NOTICE OF MEETING

Planning and Environment Committee Meeting No. 6/14

Planning and Environment Committee AGENDA NO. 6/14

F. Building Height and Windows

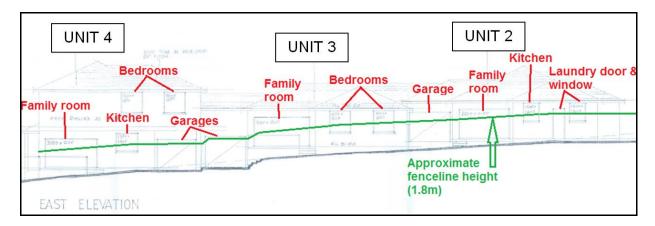
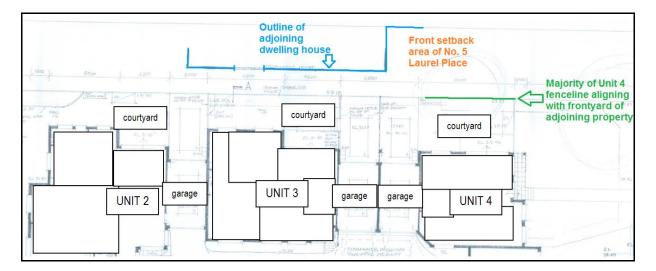
"Request more information on the height of the neighbouring property, windows and doors which face the direction of 5 Laurel Place."

Assessment Officer's Comment

- Unit 2: 5.4m (single storey no street frontage)
- Unit 3: 5.1m (single storey no street frontage)
- Unit 4: 7.9m (two storey fronting Laurel Place)

These building heights achieve compliance with Clause 4.3(2)A Building Height of the Ryde LEP 2010 which allow an overall height of 8m for multi dwelling housing facing the street and 6.5m for multi dwelling housing without a street frontage. In terms of windows directed towards No. 5 Laurel Place, the following plan extract shows the view of the development from this adjoining property with all windows labelled.

On the first floor of Unit 4 are two (2) bedroom windows. These rooms are generally not considered to be occupied for long periods at a time. Further, for the most part this unit is sited adjacent to the frontyard of No. 5 Laurel Place as can be seen in the following plan extract. Therefore, no privacy or overlooking concerns are raised in respect of these first floor bedrooms.

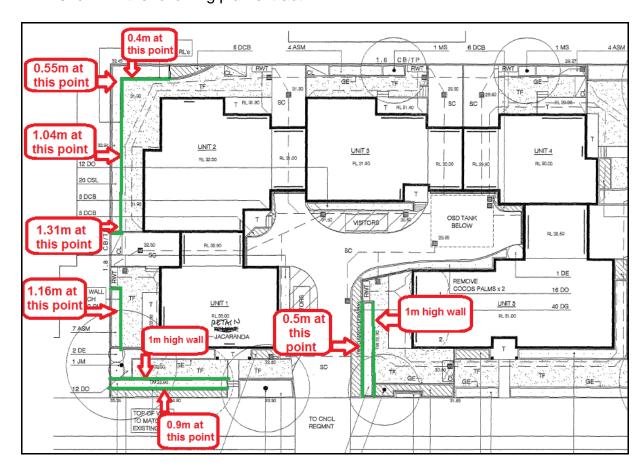
It is recognised that the existing level of privacy enjoyed by No. 5 Laurel Place may be reduced as a consequence of the construction of Units 2 and 3. Therefore, the following condition is recommended:

• Lattice screening. Provision of a lattice screen 300mm high is to be fitted on top of the side boundary fence shared with No. 5 Laurel Place for the length of Unit 2 and Unit 3. Details of compliance are to be provided in the plans for the Construction Certificate. (See Condition 27).

3. Storey Controls: Section 3.3.1(a) and (b) states the following:

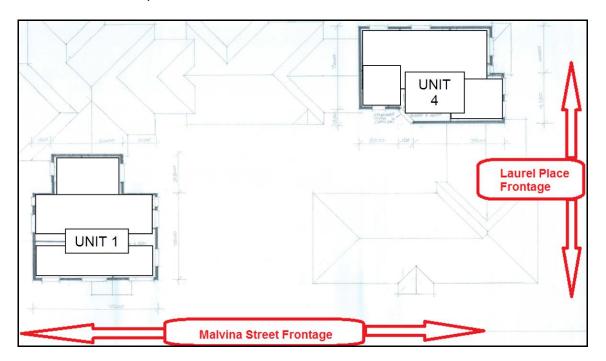
- "(a) A multi dwelling housing (attached) development must be contained within a single storey building. However, a dwelling with frontage to the street can be two storeys provided:
 - The two storey dwelling is not attached to any other two storey dwelling; and
 - ii. Council is satisfied that a two storey dwelling is suitable in terms of the surrounding streetscape.
- (b) For corner allotments only one dwelling within the development can be two storeys that being the dwelling fronting the shortest street frontage. This is usually the street to which the property is rated."

Assessment Officer's Comment

Non-compliance is considered acceptable as each two (2) storey dwelling is positioned in opposing corners of the subject site. This is shown in the following roof and first floor plan extract:

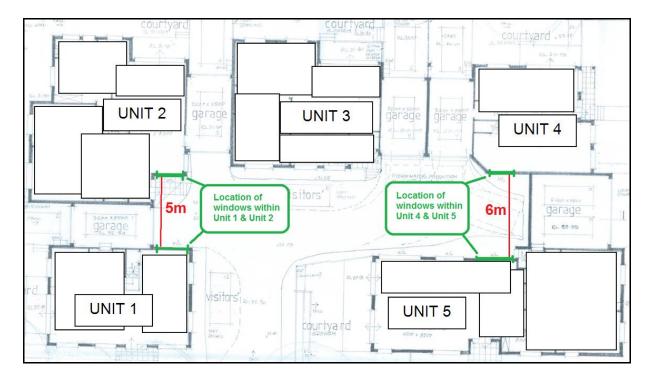
- b. Council may approve a setback of 1m less than the above standard for not more than 50% of the front elevation of the building in order to provide an irregular front elevation and to add interest to the streetscape provided that this variation does not adversely affect any adjoining property.
- c. Council may vary this standard if it is satisfied that the existing streetscape is likely to change. In this situation the setback must be not less than 7.5m for 50% of the frontage and not less than 6.5m for 50% of the frontage."

The development's primary street frontage is Laurel Place. The subject site is a corner allotment, therefore only one (1) adjoining property exists (i.e. No. 5 Laurel Place). This property contains a dwelling house with a front setback of 15.9m. Therefore, no compliance with parts a) and b) arises as the proposal at its shortest has a front setback of 6.5m. However, the front setback of this adjoining dwelling is unusually high, and as the dwellings on the adjoining site and the subject site are older-style (i.e. over 40 years) then it is considered that the streetscape is likely to change, and so part (c) above may be applied.

In applying part (c) of this control, the proposal complies as the 6.5m setback exists for a length of 8m (or 26.2%) of the frontage width. From here, the articulation in the building sees the front setback increase to 7.5m for a length of 5.5m (or 18%). Combined, a front setback of both 6.5m and 7.5m account for 44.2% of the frontage width. The parts of the development with these front setback distances apply to Unit 5 only, which is confined to the corner of the site with a dual street frontage therefore minimal impacts will occur to adjoining properties.

PHOTO showing view of the wall from lowest point to highest

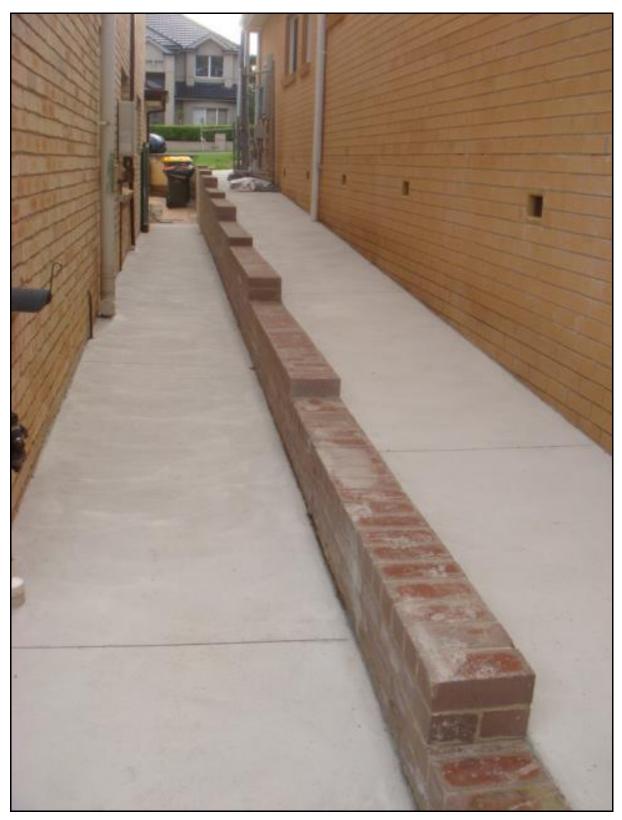
The unauthorised building works consist of a modest brick retaining wall constructed adjacent to the northern boundary and located wholly within the property known as LOT 71 D.P. 12753 35 Aeolus Avenue, Ryde, as depicted in the photos below. A survey plan prepared by registered surveyor from G.K Wilson and Associates dated 10 April 2014 has been submitted to confirm position of the retaining wall up to the boundary.

The building works consisting of a brick retaining wall constructed without the approval by the Consent Authority. (Council) However, having regards to this the Environmental Planning & Assessment Act – 1979 – Section 149(A) - "Act" allows a person to lodge a Building Certificate Application with the Consent Authority (Council) for determination in relation to unauthorised building works.

The applicant has provided a survey plan prepared by a registered surveyor confirming that the brick wall is wholly within the subject property. Any encroachment by the footings or the subsoil drainage is considered a private civil matter between the owners.

The plan showing the site and the subject Timber Log Retaining Wall located adjacent to the Northern boundary

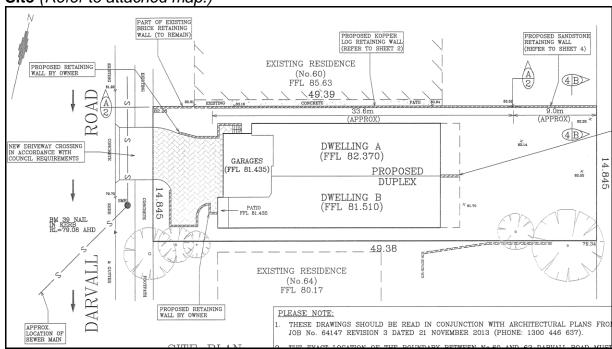
- 2. The unauthorised Timber Log Retaining Wall does not detrimentally affect the amenity of the area
- 3. The unauthorised Timber Log Retaining Wall adjacent to the northern boundary can be modified and upgraded with the installation of additional H5 posts in accordance with the requirements of the standards and certified by a Professional Engineer from Nasseri Associates Civil Hydraulic & Structural Engineers as being structurally adequate prior to the issue of the building certificate. A separate order will be issued under section 121B of the Environmental Planning and Assessment Act 1979 upon the owner to ensure that this happens.

- 4. The agricultural drainage line located immediately behind the wall is in accordance with the plans prepared by Nasseri & Associates and will be connected to a suitable stormwater disposal system. In the meantime, the agricultural drain discharges onto the construction site.
